## **MICHAEL GRIMES SUBDIVISION**

APPLICATION NUMBER 12 DATE September 2, 2010  
 APPLICANT Michael Grimes Subdivision  
 REQUEST Subdivision

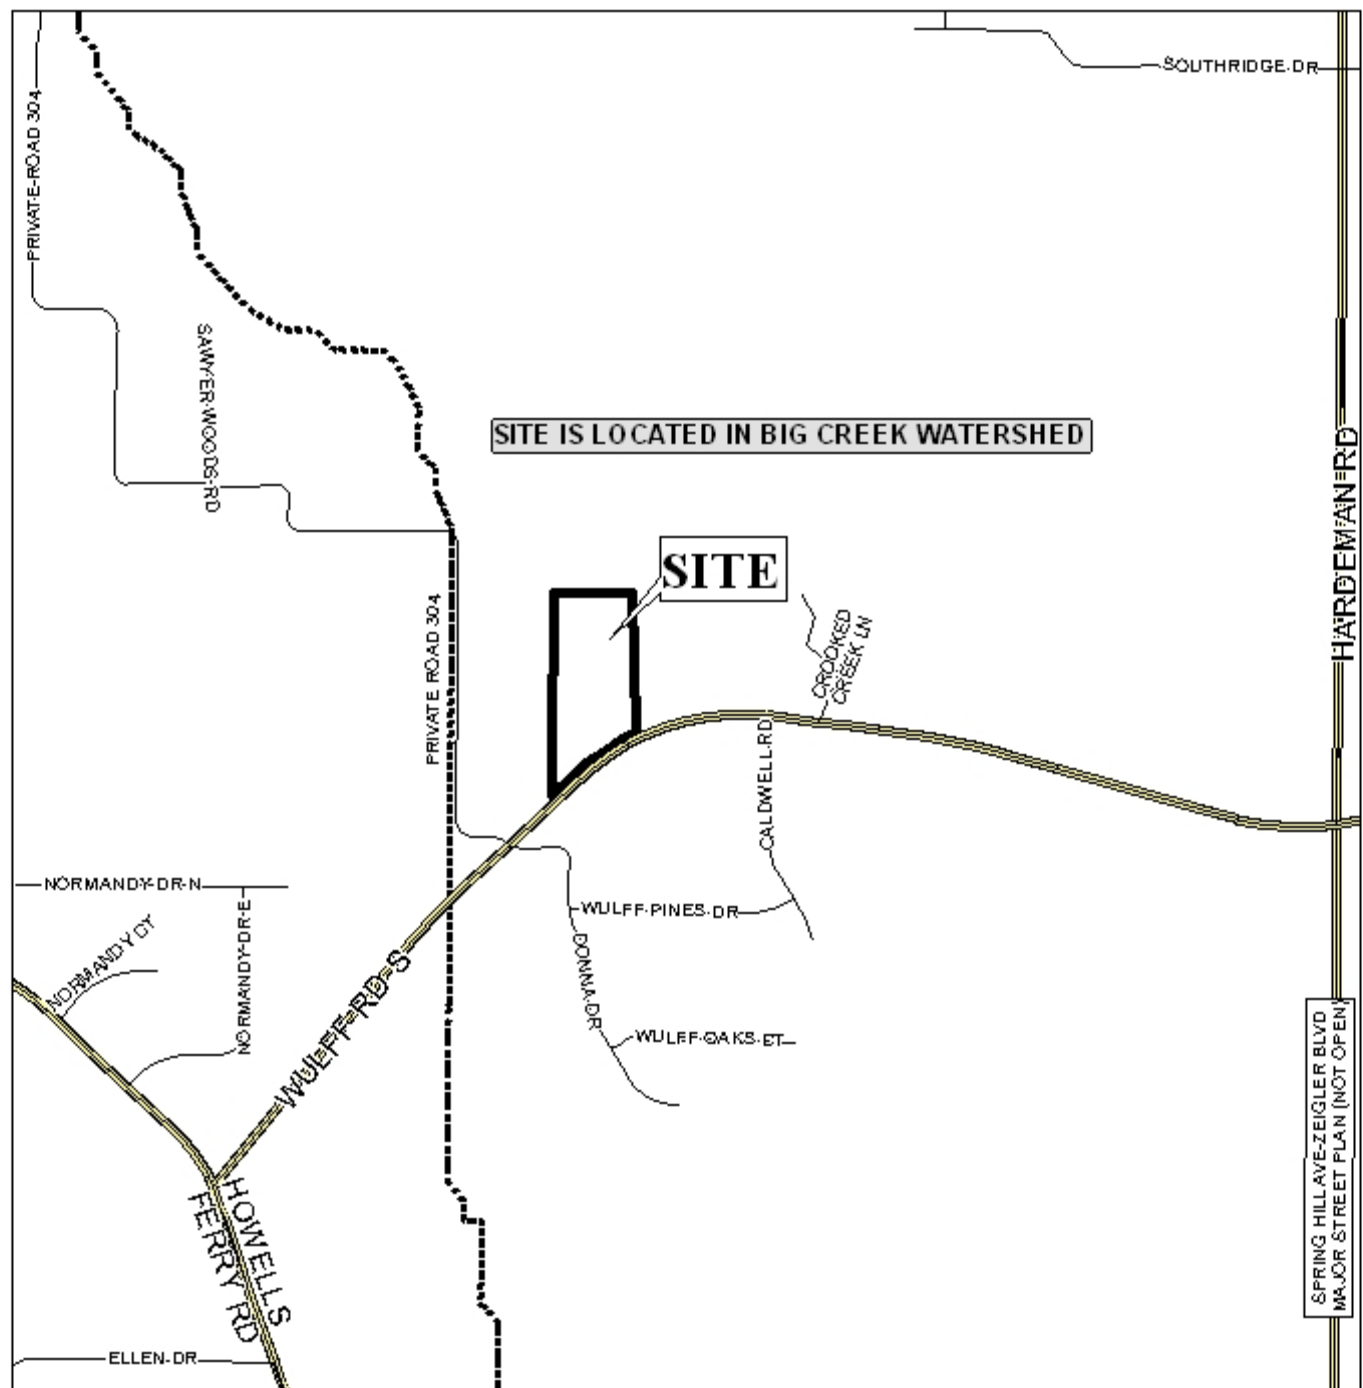
The plat illustrates the proposed 8.9 ± acre, 4 lot subdivision, which is located on the North side of Wulff Road South, 650'±West of Caldwell Road – within the planning jurisdiction. The applicant states that the site is served by public water and individual septic tanks.

As proposed, Lot 4 is considered a flag lot. Section V.D.1 of the Subdivision Regulations states that flag lots shall generally not be allowed, but may be permitted in certain circumstances. This section also includes the following statement: *“Requests for panhandle or flag lots shall be accompanied by evidence showing that each panhandle or flag lot is necessary to allow the site owner reasonable use of the site or to alleviate a situation that would otherwise cause extreme hardship.”* The applicant did not provide any evidence or justification for the flag-lot request.

Based on the preceding, the application is recommended for Holdover until the October 7<sup>th</sup> meeting, so that the applicant can provide the following information by September 17<sup>th</sup>:

- 1) Justification and evidence supporting the request for a flag lot, in accordance with Section V.D.1. of the Subdivision Regulations.
